PARKSIDE TOWNHOMES
 RAMSEY, MINNESOTA
 LANDSCAPE LAYOUT PLAN
 FOR
COR AT RAMSEY LLC
 3313 LAKESHORE COURT, CHASKA, MN 55318

DRAWN BY	BH
DATE	01/17/2023
REVISIONS	
PROJECT NO.	22-164
	L1.1

Status as of 01/19/2023 08:14 AM

LANDSCAPE NOTES + REQUIREMENTS:

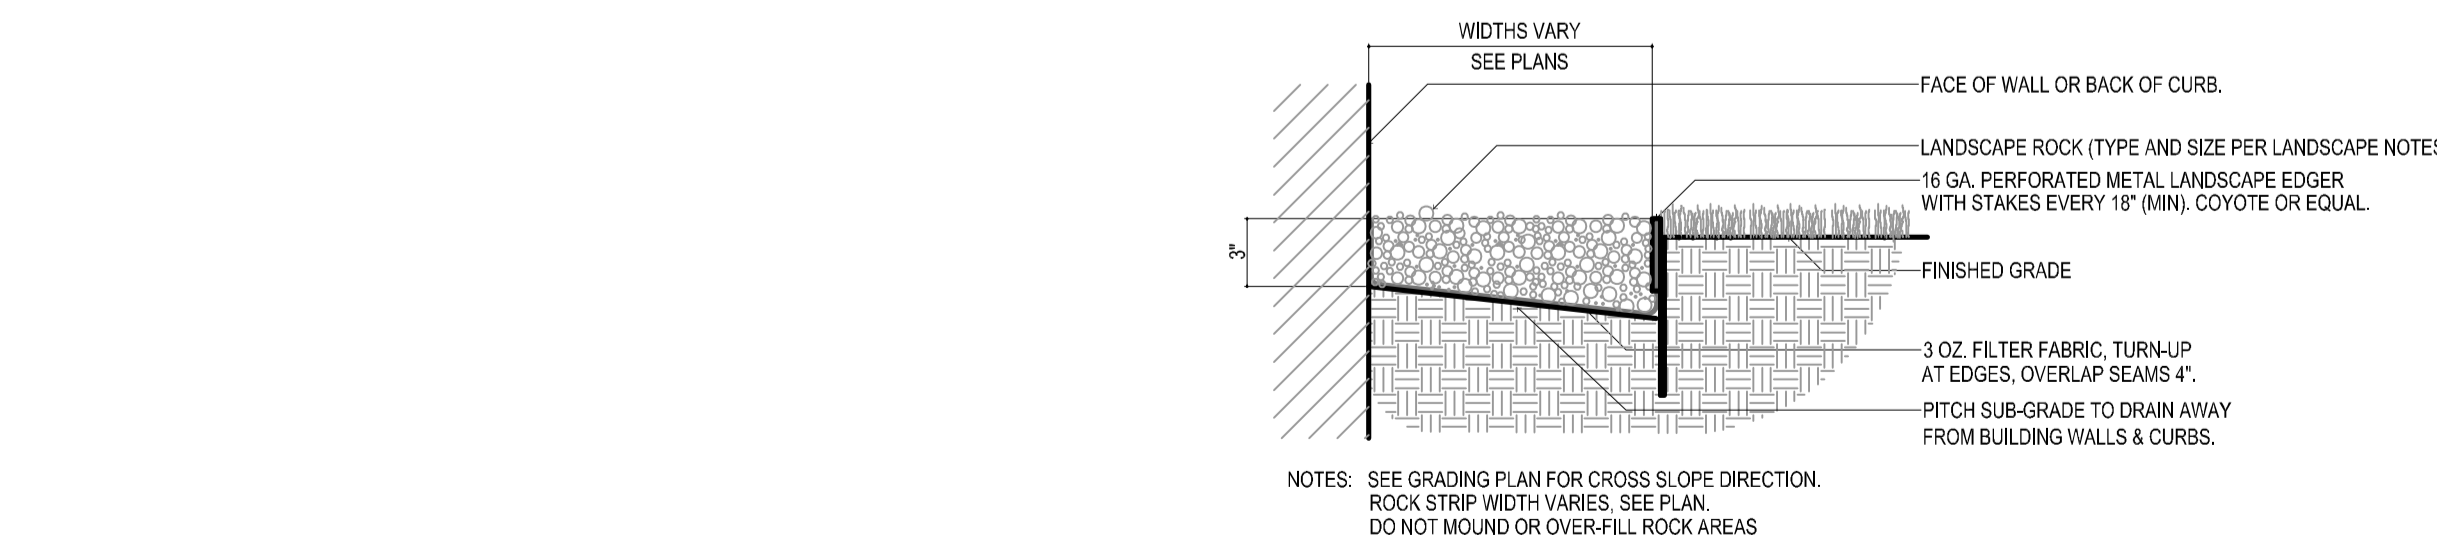
The required Development Agreement will specify that all plantings are subject to a two (2) year Maintenance Guarantee.

Any substitutions to either species or size must receive approval from the City prior to installation. Modify Note #16 to include this language.

Add an Irrigation Note that specifies that the irrigation system must include a rain sensor AND water efficient technology, such as a smart controller.
